Access Compliance Report Public Rights-of-Way (Pedestrian Signals)

Main Street: BALL_RD Cross Street: GILBERT_ST Location: SE

ADA ID: SGRK210927173814 Signal Type: One Push Button-Non APS Overall Compliance: No Severity Scores: BTN 1: 25 BTN 2: N/A No BTN: N/A

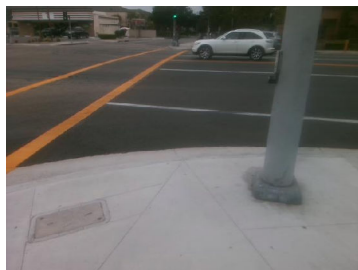
OC Std/PROW: MUTCD 4e.08, R404.2, R404.3

Possible Solutions: Replace Signal Push Button With APS Button. Remove & Relocate Sign.
